PERMIT

SEWAGE DISPOSAL SYSTEM

MARYLAND STATE DEPARTMENT OF HEALTH

HOWARD COUNTY

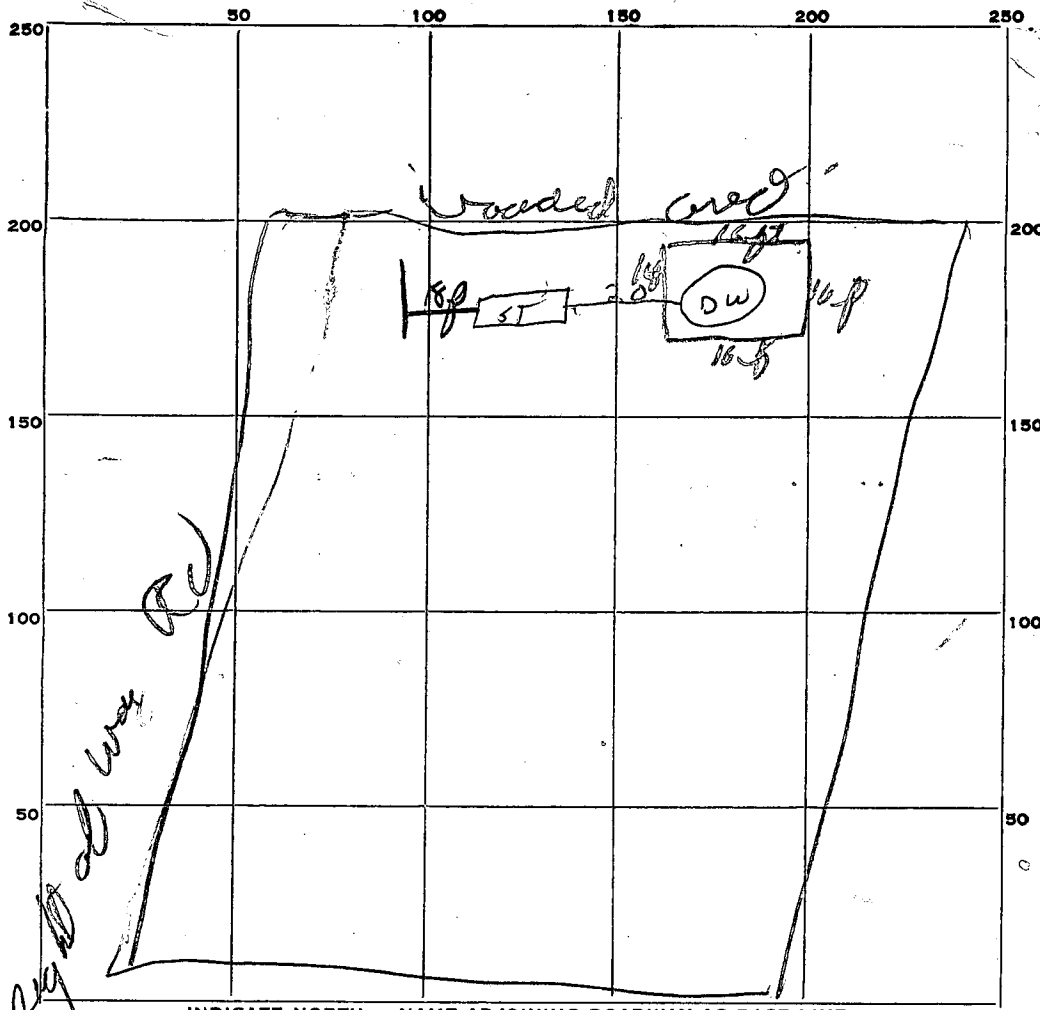
OTHER Dry well - 375 sq. ft. absorbent sidewall area below inlet pipe. Inlet pipe 4 ft. below grade. Max. depth permitted for dry well below original grade is 14 ft.

Place dry well at a point about 129 ft. in from lot line parallel with right-of-way road and about 10 ft. in from wooded area.

REMARKS 6-7-67 not enough gravel - needs about 6 inches load. - have not built - will have to put line from tank to within 5 ft of where house is to be located.

6-9-67 Jpp OK
